s110_nrf51822_5.x.x migration document

Introduction to the s110_nrf51822_5.x.x migration document

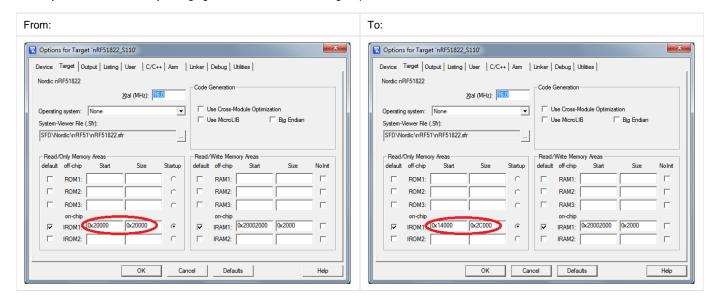
The flash requirements for the S110 SoftDevice have changed from 128kB to 80kB as of this version. All future releases of the S110 SoftDevice will require 80kB of flash memory (i.e. CODE_R1_BASE = 0x00014000). To adapt to this new size, applications will need to redefine their base addresses from 0x00020000 to 0x00014000.

In Keil, you can achieve this by changing the IROM1 value in the target options:
